UNITED STATES PATENT AND TRADEMARK OFFICE

APPLICATION NO.	FILING DATE	FIRST NAMED INVENTOR	ATTORNEY DOCKET NO.	CONFIRMATION NO.
10/758,194	01/16/2004	Cam Beatty	388.0002	4901

Office Action Summary	Application No. 10/758,194	Applicant(s) BEATTY ET AL.	
	Examiner Mark A. Deuble	Art Unit 3651

DETAILED ACTION

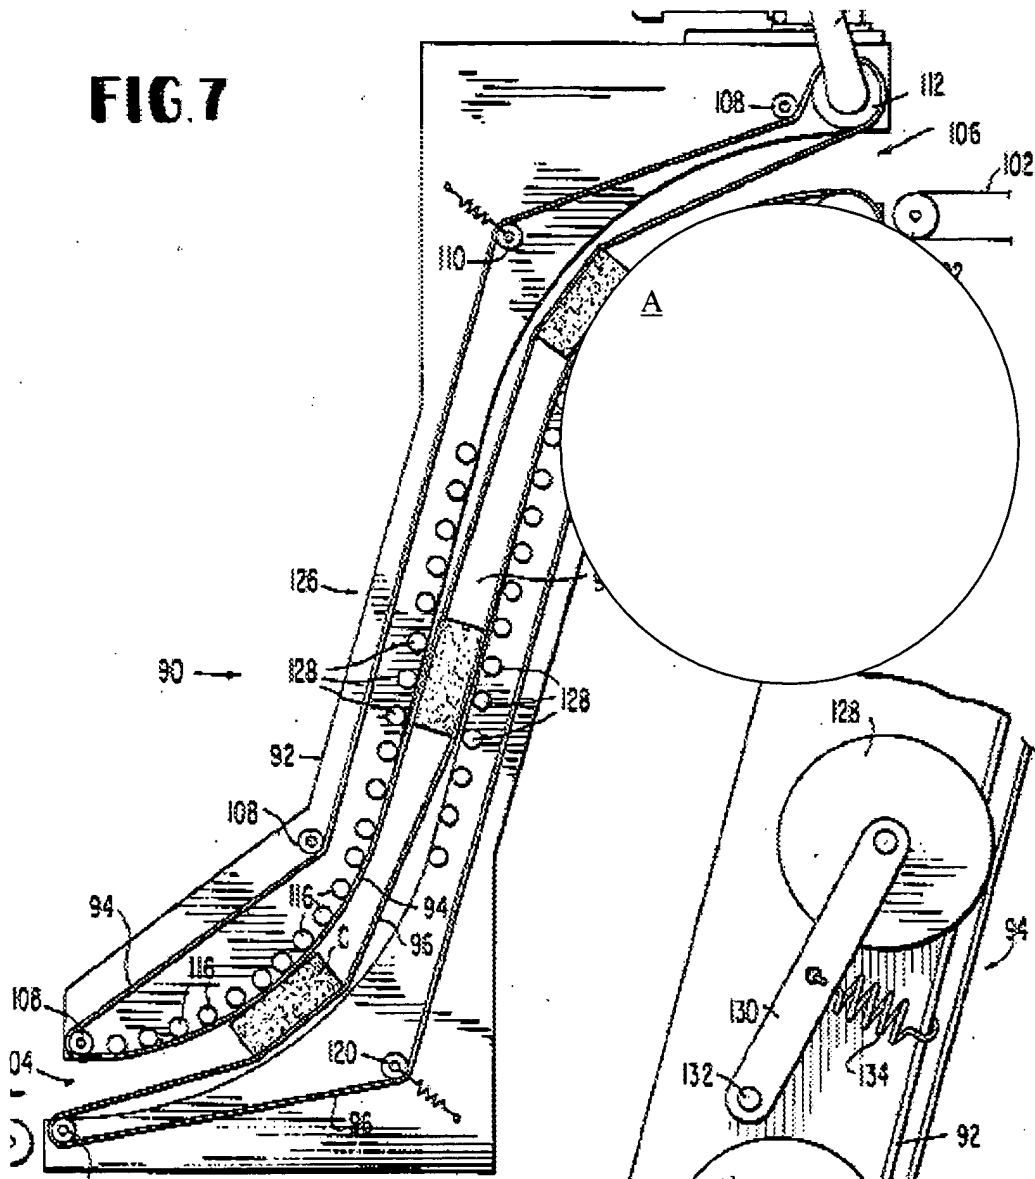
Hurd shows generally all the structure required by the claims except for cylindrical guide elements required by claims 6-7 and 10. Instead of large cylindrical guide elements, Hurd utilizes a plurality of small rollers to form large curves in the transport path. However, The British document teaches that a plurality of small guide rollers 26 may be used interchangeably with one large guide roller 16 as they are art recognized functional equivalents. Therefore it would have been obvious to one of ordinary skill in the art at the time of the invention to replace the small rollers 116, 124 of Hurd with large cylindrical rollers as taught by the British document. When this is done, the rollers would form first and second main guide elements that

are separated by a select distance and that are generally cylindrical with substantially equivalent diameters. Furthermore, the vertical distance separating the inlet and outlet would correspond to the sum of the diameters of the first and second guide elements and the distance separating them. Furthermore, because the first conveying element would contact approximately 90° of the circumference of the large guide roller replacing the guide rollers 124 and because the curve defined by these rollers 124 appears to cover approximately $\frac{1}{4}$ of the vertical distance between the inlet and the outlet, the diameter of the main guide roller would cover approximately half the

vertical distance between the inlet and the outlet (see the roller R added to the figure below).

Furthermore, because the curvature of the large roller would be equivalent to that of the rollers it replaces, the roller would have a low bending force on the object being conveyed to avoid

damaging the object. Thus, when Hurd is modified according to the teaching of the British document, it would have all the structure required by claims 6-7 and 10.
